TITLE: SUNPORT ACE GIBSON AND GIRARD IMPROVEMENTS

PROPOSED BASIN MAP
AND DRAINAGE REPORT

AVIATION CENTER OF EXCELLENCE

MDP EXCELLENCE
CONCEPTUAL GRADING AND DRAINAGE PLAN

DRAINAGE BASIN MAP
PROPOSED FUTURE DEVELOPMENT

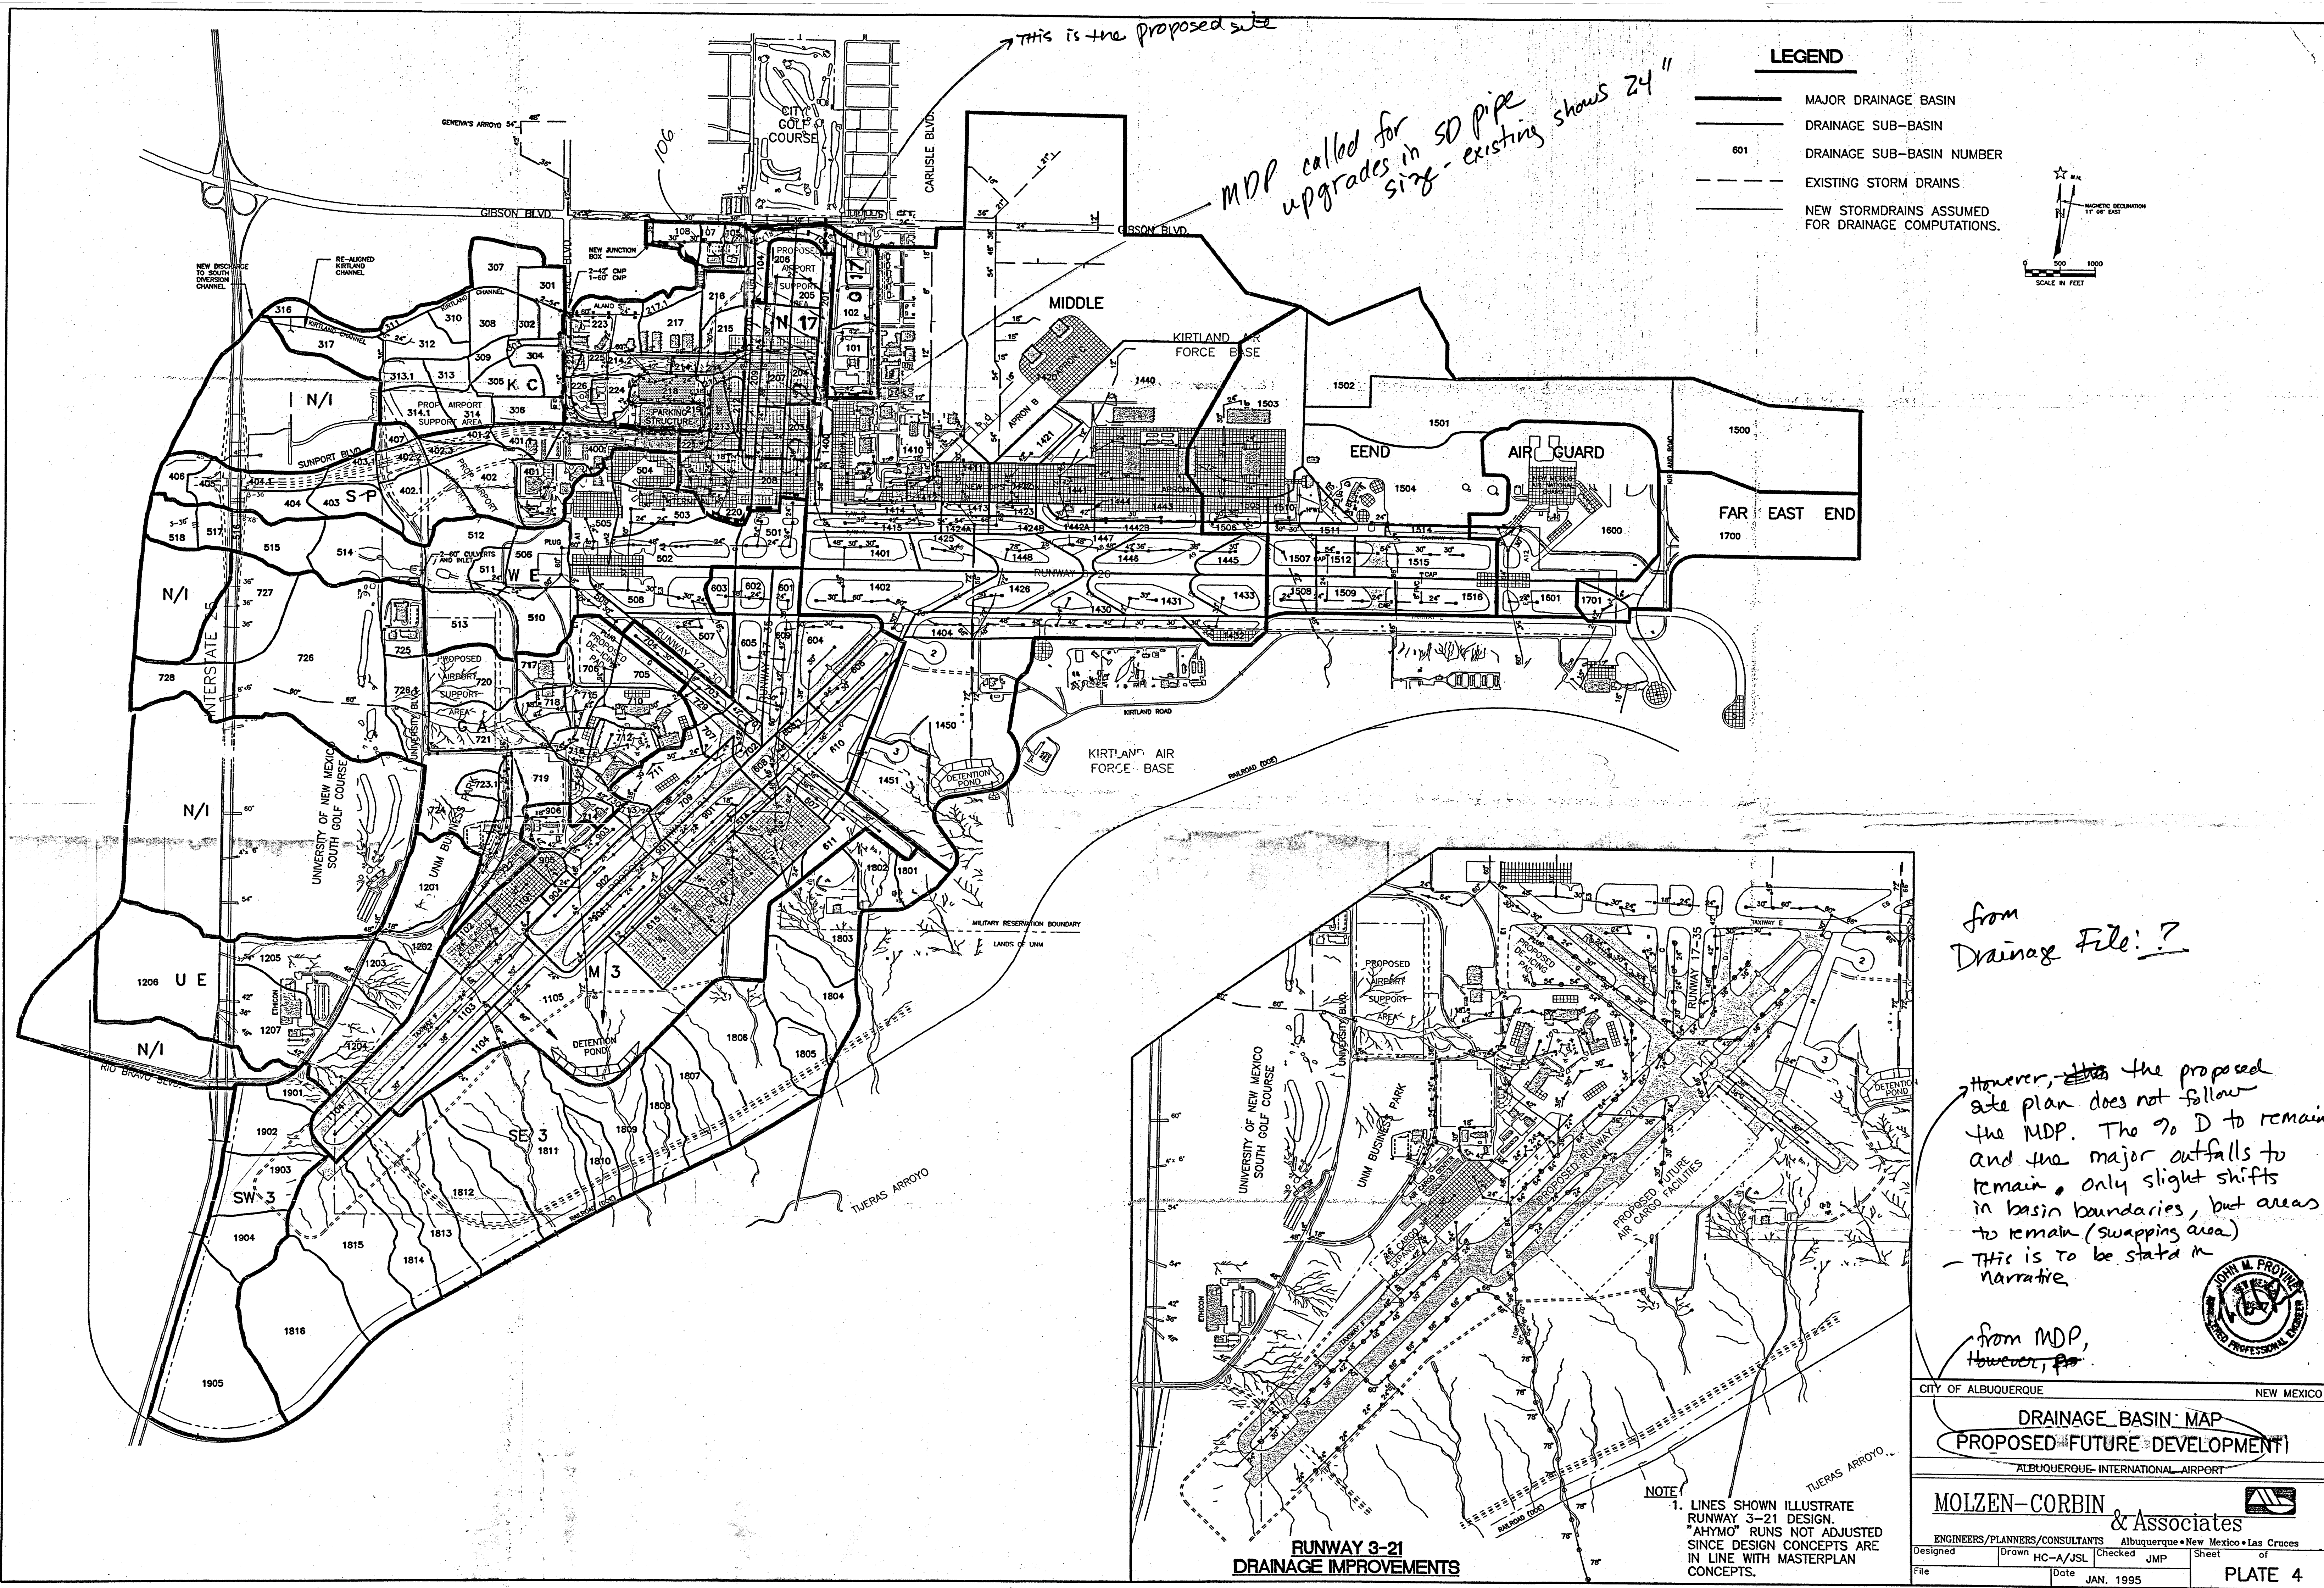
from Drainage File: ?

However, the proposed site plan does not follow the MDP. The 90 D to remain and the major outfalls to remain, only slight shifts in basin boundaries, but areas to remain (swapping area) - This is to be stated in narrative.

from MDP, however, for
